# Tier 1 Tables 2.2.3-1 through 2.2.3-4 and Table 2.2.3-6; and Figure 2.2.3-1 Passive Core Cooling System

Provide precise references for ITAAC items in the tables. Correct Tier 1 Figure 2.2.3-1 for the passive core cooling system.

Figure 2.2.3-1 (Sheet 2 of 2) Passive Core Cooling System

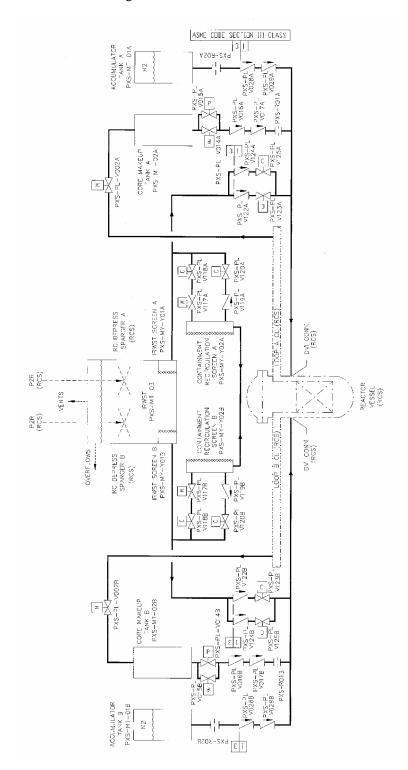
The figure change adds orifice numbers.

**Tier 1 Figure 2.2.3-1** Revise Tier 1 Figure 2.2.3-1 as follows:
